Application Number	10/0535/FUL	Agenda Item	
Date Received	8th July 2010	Officer	Mr Tony Collins
Target Date	2nd September 2010		
Ward	Queen Ediths		
Site	1 Mowbray Road Cambridge Cambridgeshire CB1 7SR		
Proposal	Change of use from dwelling to bed & breakfast.		
Applicant	Mr George Pippas 1 Mowbray Road Cambridge Cambridgeshire CB1 7SR

10/0535/FUL

1 Mowbray Road Cambridge Cambridgeshire CB1 7SR

REVISION NO:	LOCAL AUTHORITY: Cambridge City Council
TITLE: Parking Layout	CLIENT: Mr. G. Pippas
M.R. DESIGNS THE DESIGN SHOP ALL SAINTS ROAD NEWMARKET SUFFOLK CB8 8ES Tel 01538 663277	Site Address: 1 Mowbray Road, Cambridge.
SCALE: 1:50	Reference No.: SRD/5956/03

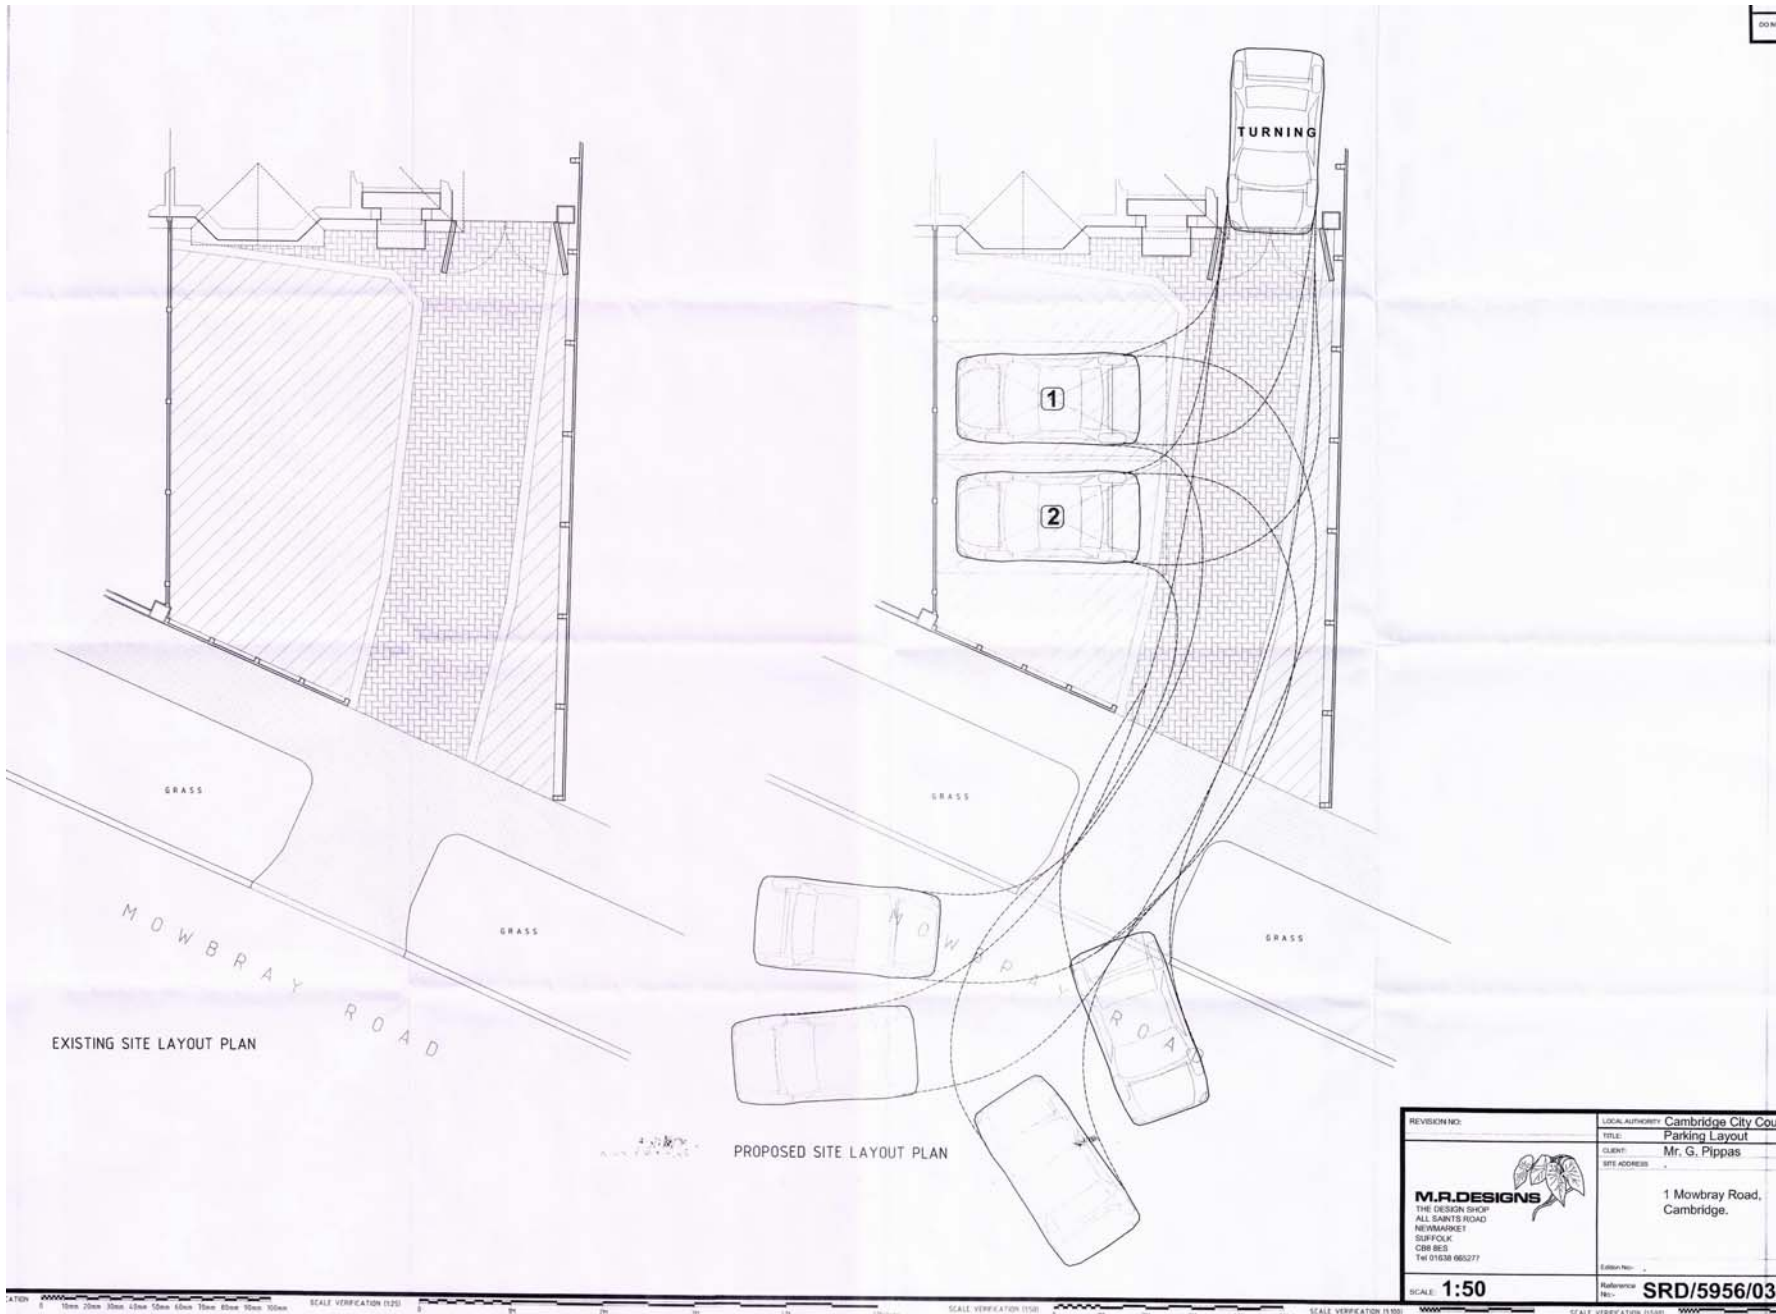
- 6.1 Refusal originally recommended because three cars could not be parked in a manner which would allow them to enter and leave in forward gear.
- 6.2 Following the submission of a revised layout, the highway authority gave the following amended advice.

- 6.3 With the removal of the gate as an obstacle to manoeuvring it is possible to provide the two parking spaces (as shown) for the development to achieve safe access to the carriageway - a reasonable, practicable solution.

- 6.4 The retention of the gate may otherwise provide a deterrent to safe access.
- 6.5 This level of provision does not exceed the maximum level allowable within the Local plan parking standards, and so would comply with local authority parking policy, although the proposal has potential to generate car parking demand in excess of the level of provision. On such occasions, some additional car parking may appear on-street. However, this would not be viewed by the highway authority as grounds to object to the proposal, as the area around the site has on-street controls that would prevent parking in locations that would endanger highway users.

- 8.6 The original application showed a car parking layout with three spaces in front of the house. The local highway authority objected to this layout on the basis that vehicles would be unable to enter and leave the site in forward gear, and that if vehicles were to reverse out of, or on to, the ring road at this point, they would create a threat to highway safety. Following further discussion with the applicant, and a joint site visit by the case officer and a development control engineer from the highway authority, it was agreed that three vehicles could not be accommodated within the space in front of the building in a manner which would avoid a threat to highway safety. As a result of this visit, the applicant has submitted a revised car parking layout, which shows space for only two cars.

- 8.7 I am satisfied that the revised layout would allow vehicles to access and leave the car parking space in a safe manner, but in view of the highway authority's concern on this issue, it is important to ensure that the chance of unsafe manoeuvres is minimised. I therefore recommend three conditions for the reasons indicated. This solution is supported by the highway authority.

Condition 4: To require the setting back of the side gates. The diagram demonstrating safe manoeuvring paths requires the opening of the side gates. Guests are unlikely to choose this option over reversing into the street, and the gates must therefore either be set back from the front of the building or removed.

2. The additional bed and breakfast rooms shall not be brought into use until a scheme of landscaping for the forecourt which prevents on-site parking of cars other than in the two specified bays has been submitted to, and approved in writing by, the local planning authority. The approved scheme shall be implemented before occupation of the additional rooms, and shall be maintained thereafter.

4. The additional bed and breakfast rooms shall not be brought into use until the existing side gates of the property are removed or set back to allow the turning manouvres shown on the approved car parking layout to take place without the gates being opened. The gates shall not be restored to their present position thereafter.
